Subject: V. C. Summer Nuclear Station Units 2 and 3
Docket Numbers 52-027 and 52-028
Combined License Application – Supplemental Response to NRC
Environmental Report (ER) Information Needs NP-1, AQ-11 and
AQ-13

VCSNS Units 2 and 3
Supplemental Response to NRC Information Needs Items AQ-11 and AQ-13

VCSNS Units 2 and 3
Supplemental Response to NRC Information Needs Item NP-1

PROPOSED OWS
 MAINTENANCE ACCESS PIER (MAP)
 AND WET WELL
FIGURE 11

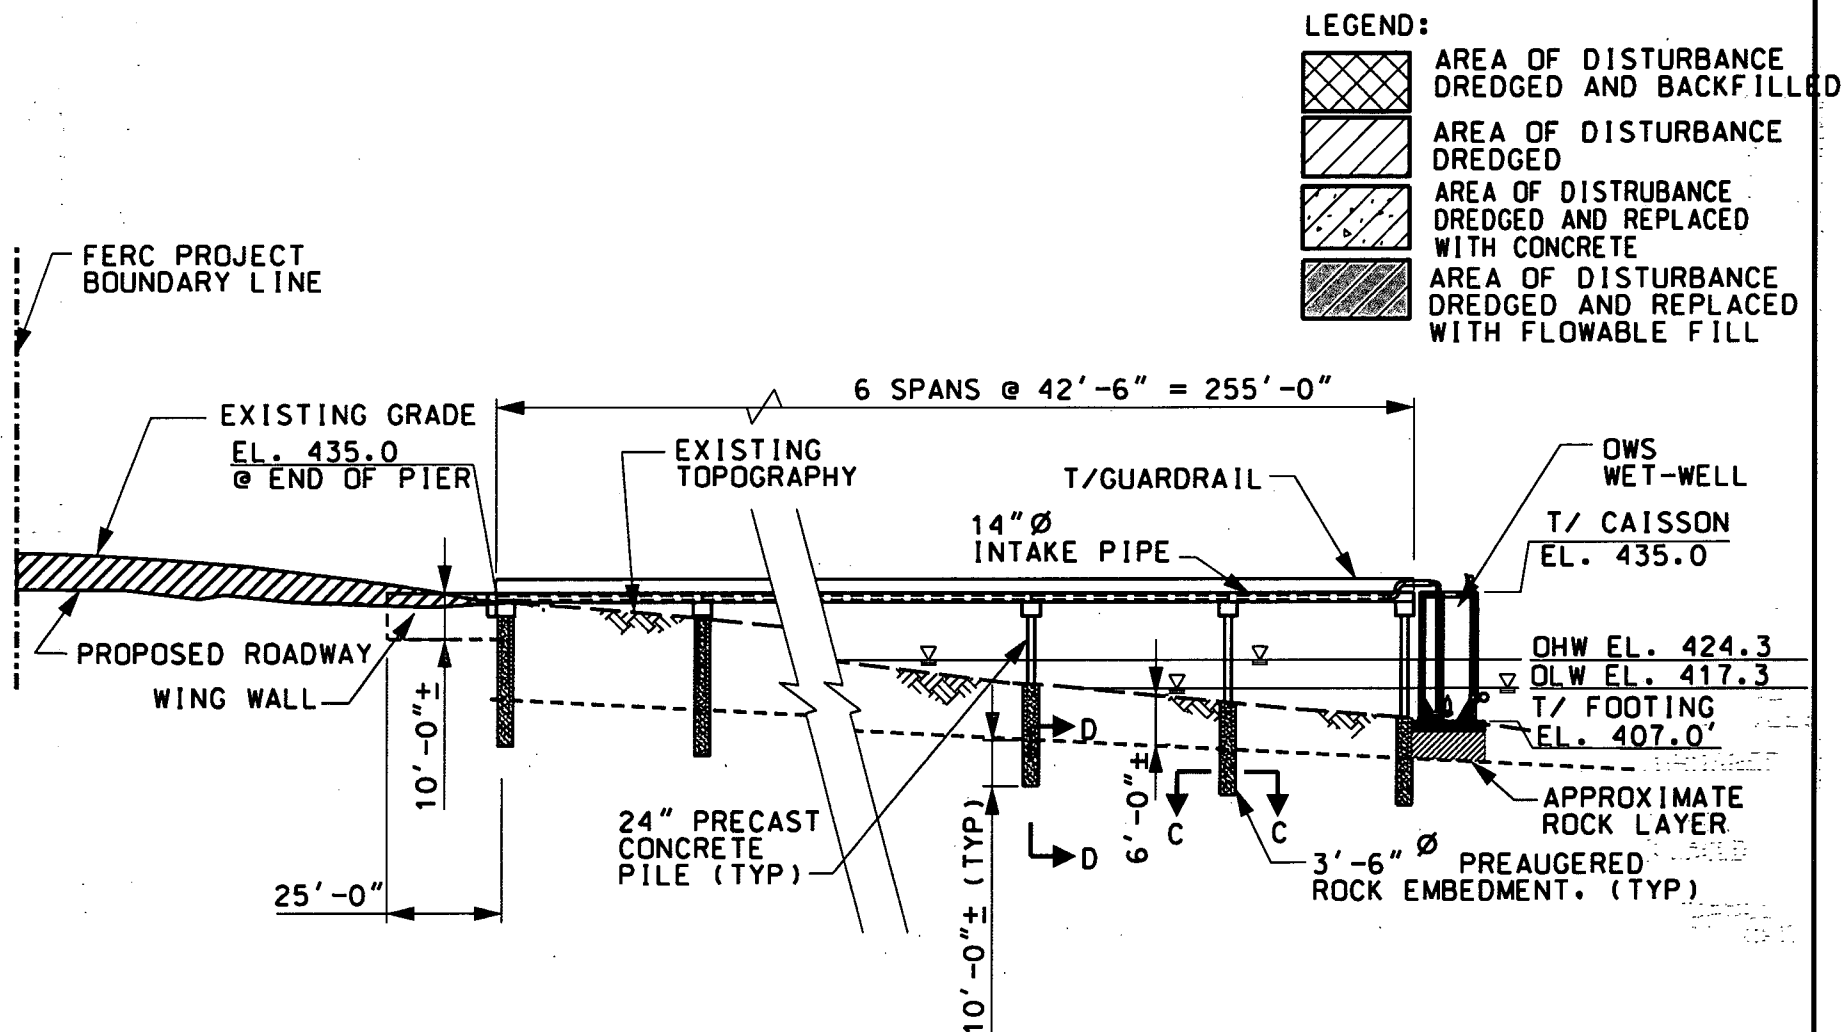
AQ-11 Supplemental Information: Describe the methods and alternate construction scenarios as related to construction of the service/offsite water intake structure. Provide a summary of the draft FERC application as related to in-water work and a copy of the final application upon submittal to FERC. Necessary details will need to include construction methods, best management practices, dimensions of the intake structure, dimensions of maintenance access pier, the size of the area to be excavated, and area encompassed by the cofferdams and turbidity curtain.

The installation of the OWS Intake Structure in the dry will require the construction of a cofferdam to encircle the entire area of the MAP and Wet Well (See **Figure 11 and 14**). A pile-faced, tied-back rock filled cofferdam will be erected within the confines of the silt curtain noted above. Upon containment of the work area, the site will be dewatered and all unsuitable soils removed and stockpiled.

Figure 8.2-1. Santee Cooper Energy Sales

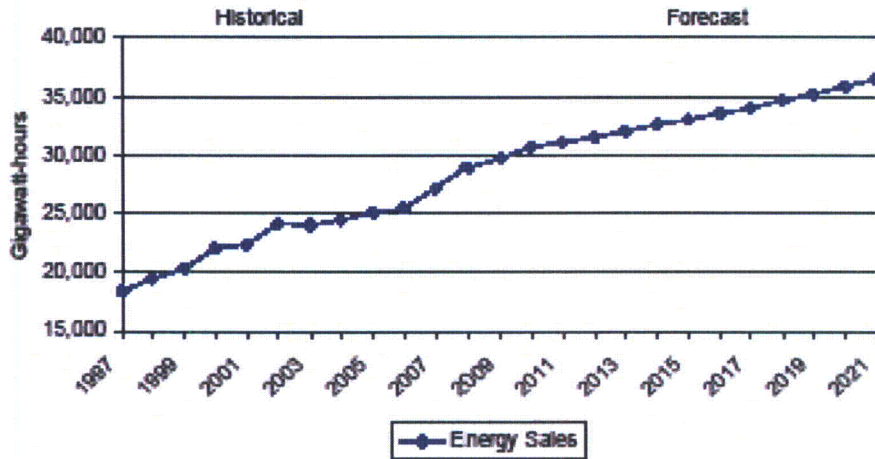
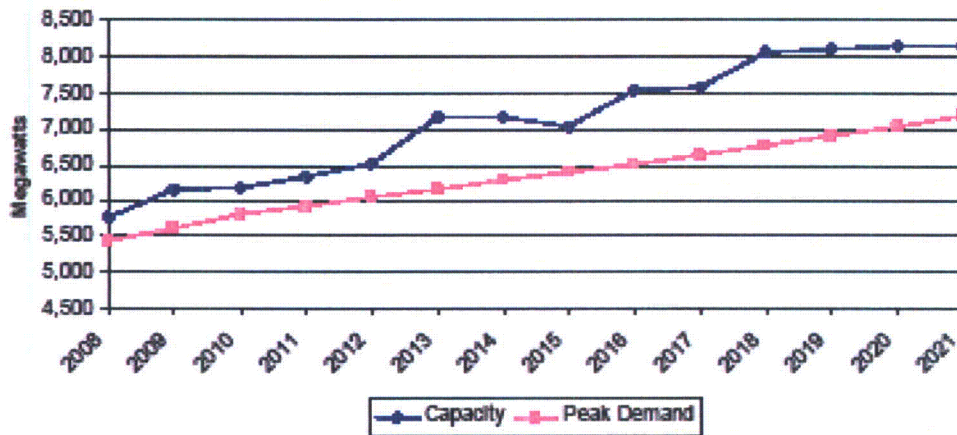
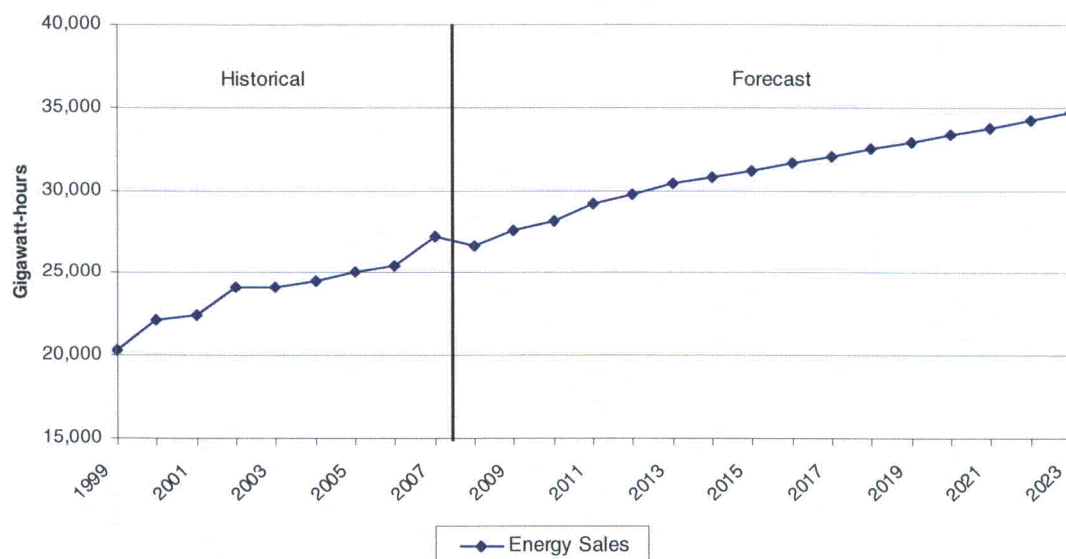
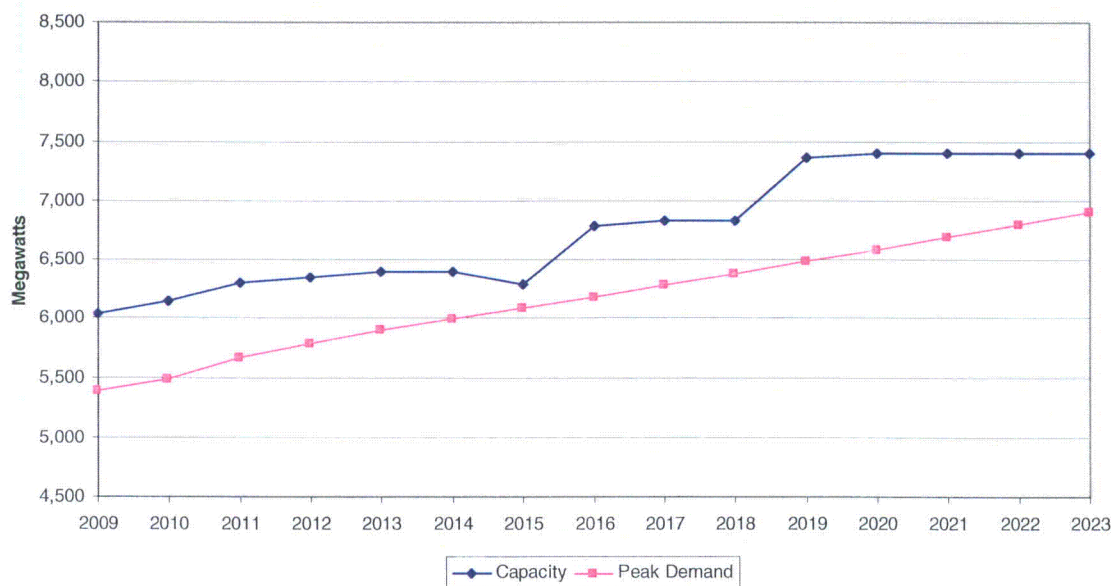
NP-1 Supplemental Information Request: Information is requested to evaluate the energy forecast 3 years past commercial operation of the 2nd reactor. Once the 2009 Santee Cooper IRP has been issued to the State Energy Office in mid-November, we request you forward to us the energy and power forecast out to a minimum of year 2022 (winter 2022/2023). The forecast should evaluate the impact of the stop-work order on the Pee Dee coal fired power plant, how the absence or delay of that generation (capacity) will impact energy and power supply out to 2022, and the impact of the potential loss of the Central Co-Op wholesale power sales agreement on the forecast out to a minimum of year 2022.

Figure 8.2-1 illustrates the results of the most recent 2009 Santee Cooper energy sales forecast and Table 8.2-1 identifies the values used to create the figure. As shown, Santee Cooper expects its energy sales to grow approximately 1.86% per year for the next 15 years, rising from 28,982,275,597 gigawatt-hours in 2008-2009 to 36,461,34,693 gigawatt-hours in 2024-3 (Santee Cooper 2008). In large part, this growth is attributable to Santee Cooper directly serving one of the state's fastest growing areas, Myrtle Beach. Santee Cooper's growth rate in its direct service area has averaged 3.5% over the past 5 years (Santee Cooper 2007). It should be noted that the projected growth rate does not include growth in Santee Cooper's direct-served large industrial sector. Growth in the large industrial sector beyond contract amounts is not assumed in the load forecast projections. For overall perspective, Figure 8.2-1 and Table 8.2-1 also include Santee Cooper historical energy sales for the past 10 years.

Replace Figures 8.2-1 and 8.2-2 (See next page)
